# UNITED STATES PATENT AND TRADEMARK OFFICE

10/540,089

**Office Action Summary**

### DETAILED ACTION

Figure 1

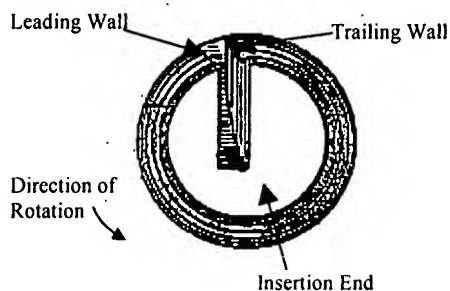
Regarding claim 11, Olson discloses a device comprising a generally cylindrical anchoring portion and a number of slots extending from the insertion end (see Figure 1 below). The anchoring portion includes an insertion end and includes an external screw thread. The slots are defined by a leading slot wall and a trailing slot wall related to the direction of rotation defined by the external thread, wherein at least the radial outermost part of the trailing slot wall defines an angle alpha with the radial direction and slopes obliquely forward from within and outwardly in the direction of rotation. Regarding claim 12, Olson discloses a device wherein the entire trailing slot wall defines the angle alpha with the radial direction. Regarding claim 13, Olson discloses a device wherein the leading slot wall also slopes obliquely forward from within and outward in the direction of rotation. Regarding claim 14, Olson discloses a device wherein the leading and trailing slot walls are parallel with one another. Olson fails to disclose a device further comprising a cavity that opens out at the insertion end in communication with the slots, wherein the cavity includes a circular cross-section and widens conically in a direction towards the insertion end. Guedj teaches a device comprising an anchor portion

including a cavity that opens out at an insertion end in communication with slots, wherein the cavity includes a circular cross-section and widens conically in a direction towards the insertion end in order to guide bone shavings cut by the slots in the direction of the cavity (column 3 lines 11-18). It would have been obvious to one having ordinary skill in the art at the time the invention was made to manufacture the device of Olson further comprising a cavity that opens out at the insertion end in communication with the slots, wherein the cavity includes a circular cross-section and widens conically in a direction towards the insertion end in view of Guedj in order to guide the bone shavings cut by the slot in the direction of the cavity.
